Ayrlawn Preliminary Plan 120120110

Staff Report Date: 7-6-12

Application to subdivide 0.76 acres of land into five lots for five one-family detached dwellings

5923 JOHNSON AVENUE
PARCEL A, BLOCK 23, AYRLAWN
PROPOSED LOTS 9 THRU 13
PRELIMINARY TREE SAVE PLAN
FILE # 42012036E
(P.P. NO.: 120120110)

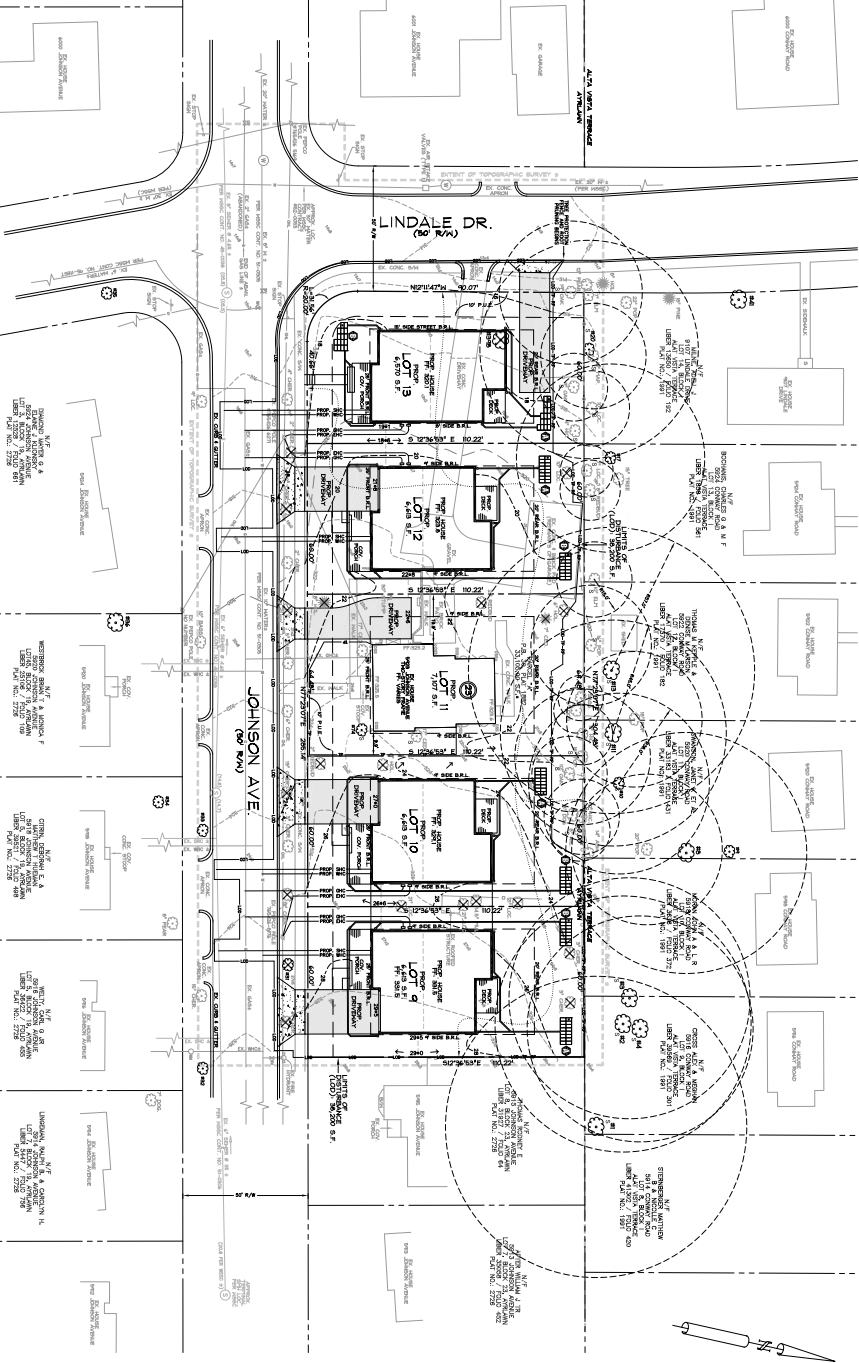
- a. Provide protection measures for tree #74 and the unnumbered 17-inch red cedar located east of the existing house on Lot 11.
 - b. Show the drywells in the same location as shown on the approved Preliminary Plan.
